Correct Installation of the solenoid valve – all air conditioning systems

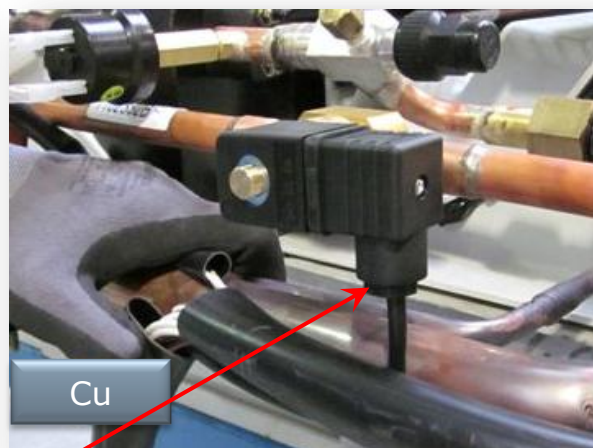
As part of product quality monitoring and analysis, we see an increased amount of solenoid valves **1102620A** which have been sent back with warranty claims asserted because of internal corrosion damage. These damages point to an incorrect positioning of the solenoid valves.

Against this background we would like to point out, that the installation of a new solenoid valve must be done mandatory according to the shown schema.

The electrical connection must **always facing down** to prevent an ingress of moisture through it.

IMPORTANT
The cable outlet must **always facing down.**
